SUBJECT: Forwards addl info re review of relief request RR2-1 to allow continued plant operation w/two pin hole leaks in 3/4 inch ASME Code Class 2 chemical injection weldment per 960814 & 15 verbal requests.

Docket 50-305
 Operating License DPR-43
 Kewaunee Nuclear Power Plant
Relief Request No. RR2-1 Request for Additional Information

Additional Information Relief Request RR2-1

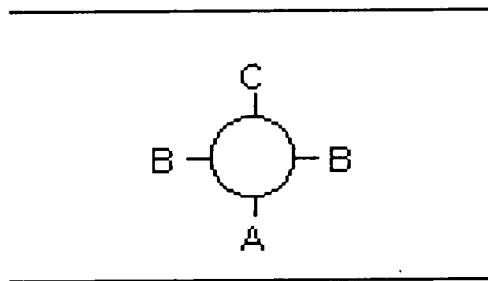
1. Gap the sockolet as required by the Welding Procedure Specifications, align the fitting and tack weld at a minimum of 2 places.
2. The tack welds are cleaned of slag and the ends visually inspected by the welder for soundness.
3. The root pass is usually started at point "A" with progression to points "B", both sides of the joint.
4. The welder then moves to the opposite side of the 16" pipe and continues the pass from points "B" to point "C".

As can be noted, all starts and stops (root, intermediate, and final weld passes) are typically in the same area of the weldment. This is due to the configuration of the socket relative to the main run. The included joint angle at point "B" is minimal with the curvature of the main run causing the bevel angle to be tighter at point "B".

Cluster porosity was identified by visual examination of the leak. The pin hole indications appear in the area of the starting or stopping point of the final weld pass at a location consistent with the weld procedure described above. All previous weld passes would have started and/or stopped at the A, B and C locations noted above which could give rise to porosity or slag inclusion at these locations. Insufficient cleaning would have resulted in covering slag or porosity in the subsequent weld passes. Porosity may be small enough to go unnoticed by the welder subsequent to the next pass of weld. A review of the fabrication traveler leaves the number of weld passes indeterminate. The Weld Procedure Specification allowed as few as two (2) passes and as many as ten (10) passes dependent upon the pipe wall thickness.
